**REVIEW OF EFFECTS OF SUPERCOMPACTED WASTE  
AND HETEROGENEOUS WASTE EMPLACEMENT  
ON WIPP REPOSITORY PERFORMANCE**

**FINAL REPORT**

Trinity Engineering Associates  
8832 Falmouth Drive  
Cincinnati, Ohio 45231-5011

U.S. Environmental Protection Agency  
Office of Radiation and Indoor Air  
Washington, DC 20460

Figure 5-1. Minimum mass of MgO required per waste package.

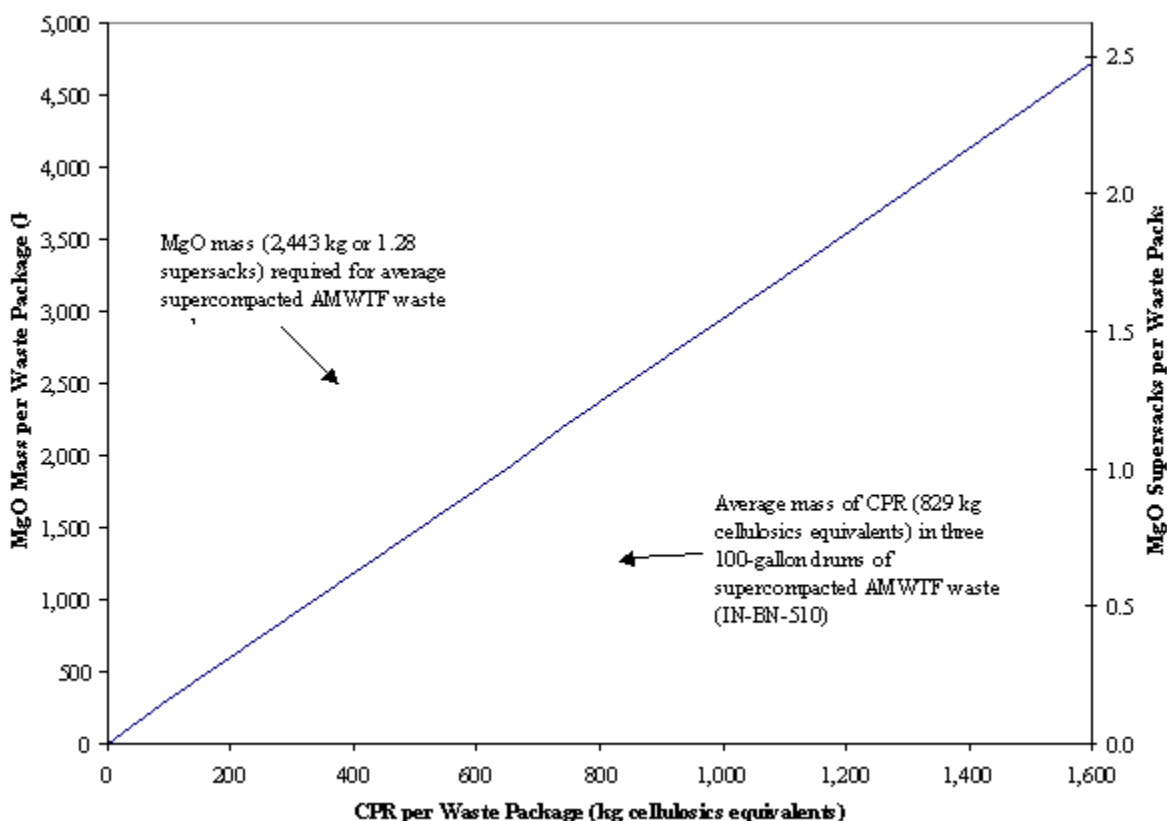
More MgO must be added to the repository than illustrated in Figure 5-1 to allow for the MgO dissolved in brine that may be released from the repository. Such releases can occur through anhydrite interbeds or intrusion boreholes and the MgO removed from the repository would not be available to react with CO<sub>2</sub>. The volume of brine that could leave the repository can conservatively be set equal to the volume of brine that could enter the repository. The amount of MgO that would be dissolved in the maximum volume of brine that could enter the repository is  $4.81 \times 10^5$  kg (Snider, 2003a and 2003b). This would require the placement of an additional 253 MgO supersacks in the repository.
